Product Change Notification / CENO-07IFFY616

CCB 3192.010 Final Notice: Qualification of MMT as a new final test site for SY89113UMY, SY89113UMY-TR, SY89112UMY and SY89112UMY-TR catalog part numbers (CPN) available in 44L VQFN (7x7x1.0mm) package.

QUALIFICATION REPORT SUMMARY

CCB 3192.010
Pre and Post Change Summary
PCN #: CENO-07IFFY616

Tape and Reel – BQM and Pin 1 Orientation

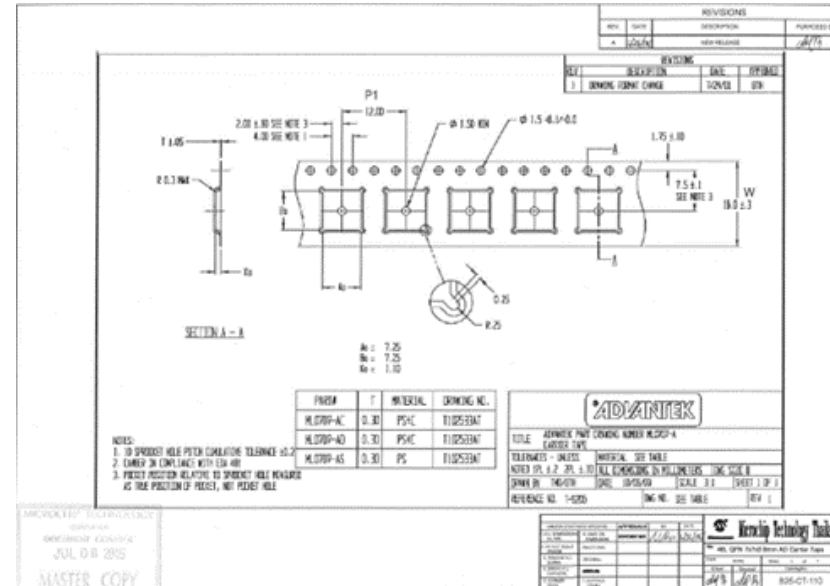
UNIS	MMT
Base Quantity Multiple (BQM)	1000 per reel	1000 per reel
Pin1 Orientation	No change (MTAI packing units)	 <p>Pin 1 Orientation in T/R Quadrant 2</p>

Tape and Reel – Carrier Tape

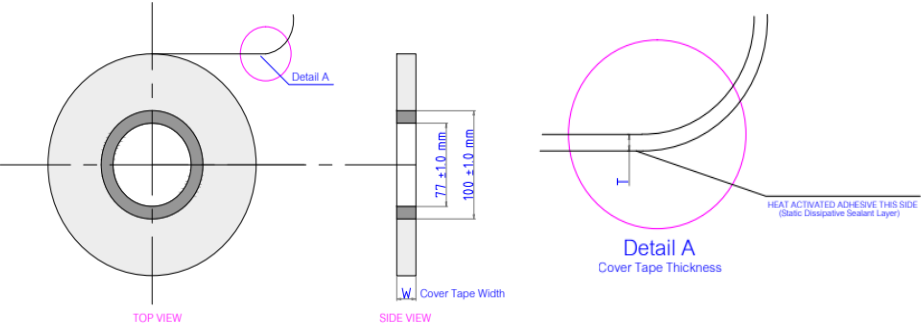
No change (MTAI packing units)

Width (mm) ±0.30	Pitch (mm) ±0.10	A0 ±0.1	B0 ±0.1	K0 ±0.1
16	12	7.25	7.25	1.10

Tape and Reel – Cover Tape

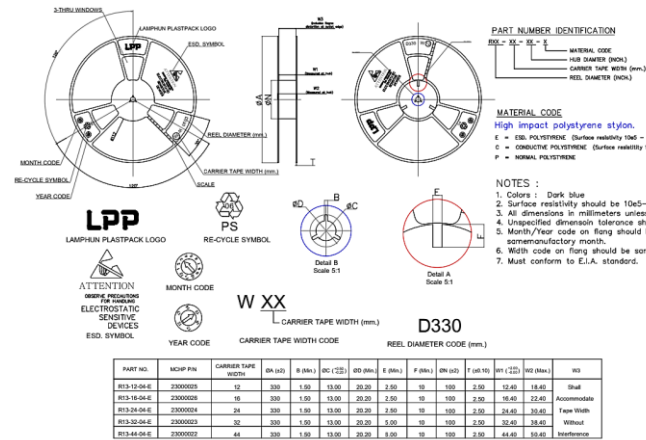
UNIS	MMT						
<p>No change (MTAI packing units)</p>	 <p>The technical drawings show a circular cover tape with a central hole. The top view shows a hole diameter of 7.7 ± 1.0 mm and an outer diameter of 10.0 ± 1.0 mm. The side view shows a thickness of 0.050 ± 0.1 mm. Detail A shows the adhesive layer, which is heat-activated and has a static dissipative resistant layer.</p> <table border="1" data-bbox="1375 949 2127 1135"> <thead> <tr> <th>Cover Tape Width (mm)</th> <th>Cover Tape Thickness (mm)</th> <th>Color</th> </tr> </thead> <tbody> <tr> <td>13.3 ± 0.1</td> <td>0.050 ± 0.1</td> <td>Clear</td> </tr> </tbody> </table>	Cover Tape Width (mm)	Cover Tape Thickness (mm)	Color	13.3 ± 0.1	0.050 ± 0.1	Clear
Cover Tape Width (mm)	Cover Tape Thickness (mm)	Color					
13.3 ± 0.1	0.050 ± 0.1	Clear
